# NORTH WEST **cambridge**

Section 73  
Design Statement  
September 2013

This Design Statement accompanies a Section 73 application made by the North West Cambridge Project Team on behalf of the University of Cambridge in relation to the outline consent for North West Cambridge scheme (11/1114/OUT and S/1886/11).

- Condition 69: Drawing Numbers –revised Parameter Plans will be submitted as part of the Section 73 Application, to address amendments to the heights in the local centre and revised positioning of the Community Centre through detailed design.

Hotel plot anticipated layout overlay on February 2013 Building Heights Parameter Plan

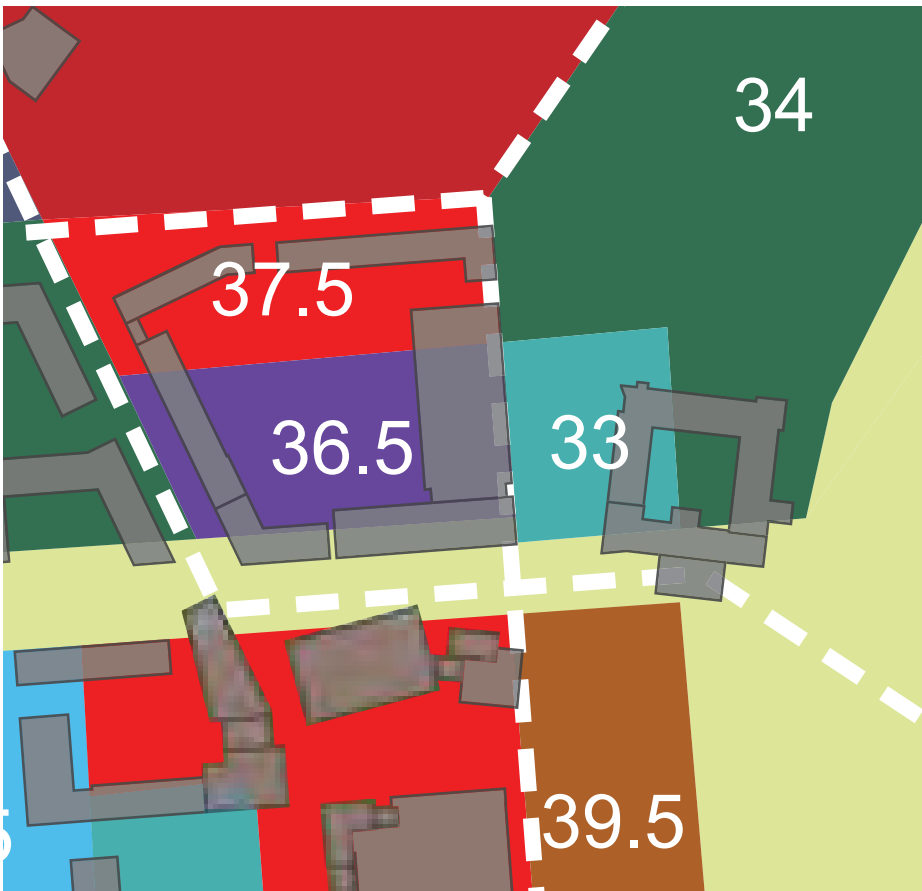
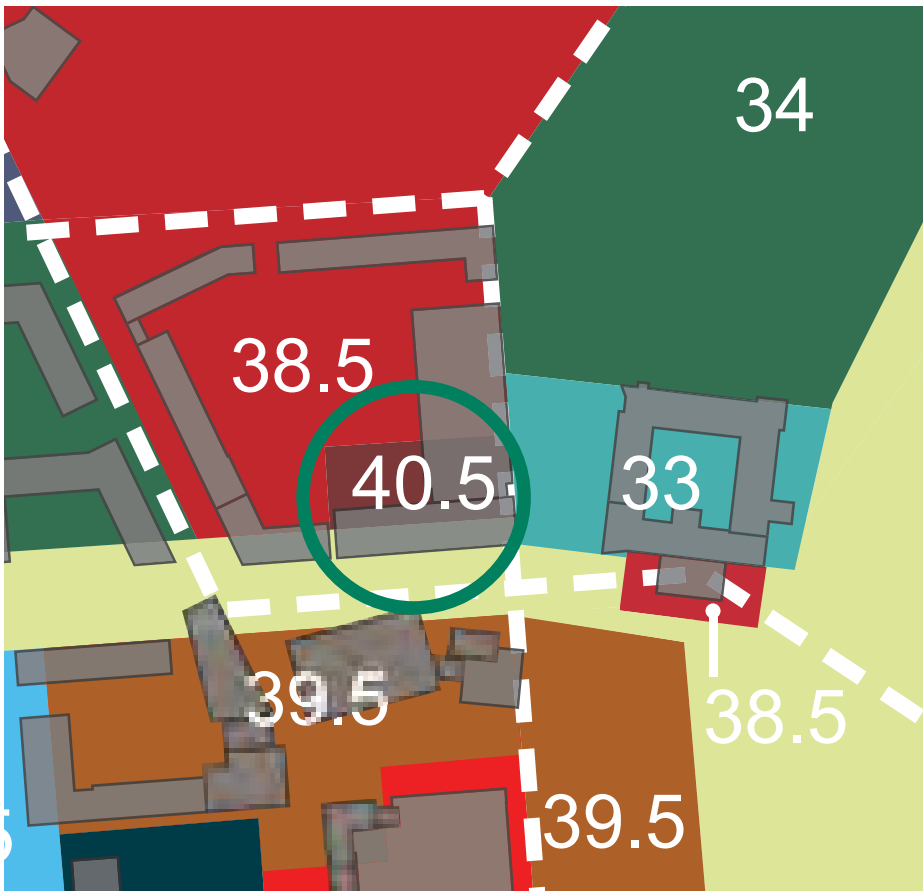
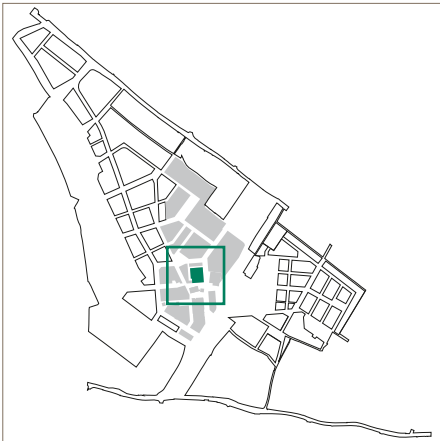
It is therefore envisaged that any hotel building will comply with Parameter Plan 05 with the maximum building height of less than 18m above ground level. However, it is anticipated that it is unlikely that the building will comply with Parameter Plan 06 and will breach the AOD.

As such we propose a new height parameter set at 40.5m AOD in this location (see diagrams opposite). This AOD is dependent on setting the ground floor level of the hotel at 22.5m AOD. This is the level of the service lane to the rear of the Lot from which the car park and hotel functions need to be serviced (servicing and car park access should be located away from Ridgeway Place). The 40.5 AOD allows for a ground floor of 5m floor to floor and 4 floors of 3.25m floor to floor. These heights provide for flexibility of use on all floors.

Lot 2 anticipated layout overlay on February 2013 Building Heights Parameter Plan

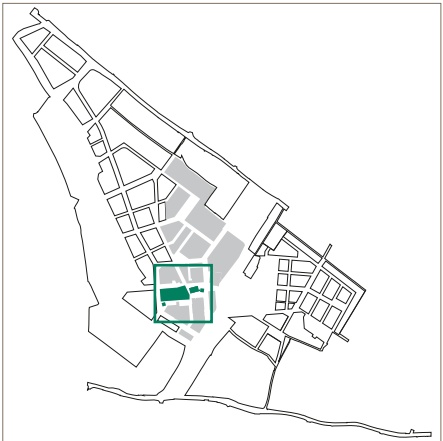
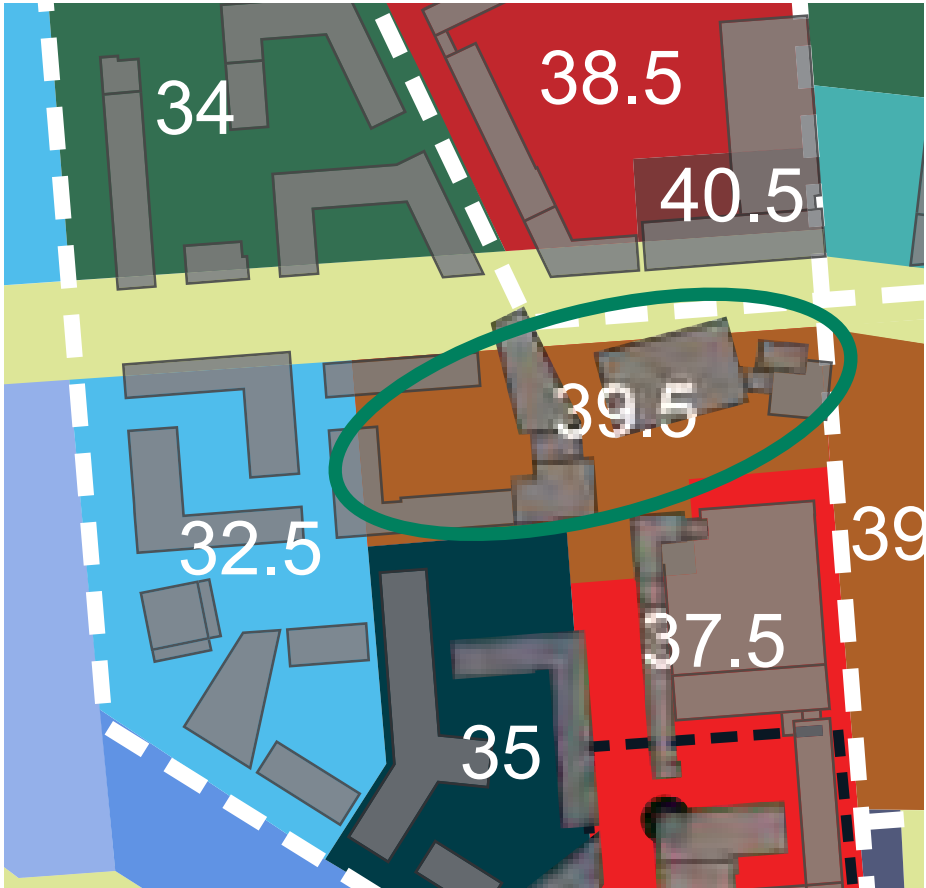
It is therefore envisaged that the building will comply with Parameter Plan 05 with the maximum building height of less than 18m above ground level. However, is it anticipated that it is unlikely that the building will comply with Parameter Plan 06 and will breach the AOD.

As such we propose a new height parameter around the Market Square to be set at 39.5 AOD. This AOD is dependent on the setting of the ground floor level of 21.4m. This ground level has been set through

extensive detailed public realm design work (Lot B Architects) and allows for a seamless public realm around the Market Square and Ridgeway Place and level access to ground floor uses from the public realm. The 39.5 AOD allows for a ground floor of 5m floor to floor and 4 further floors of 3.25m floor to floor. These floor heights provide for flexibility of use on all floors.
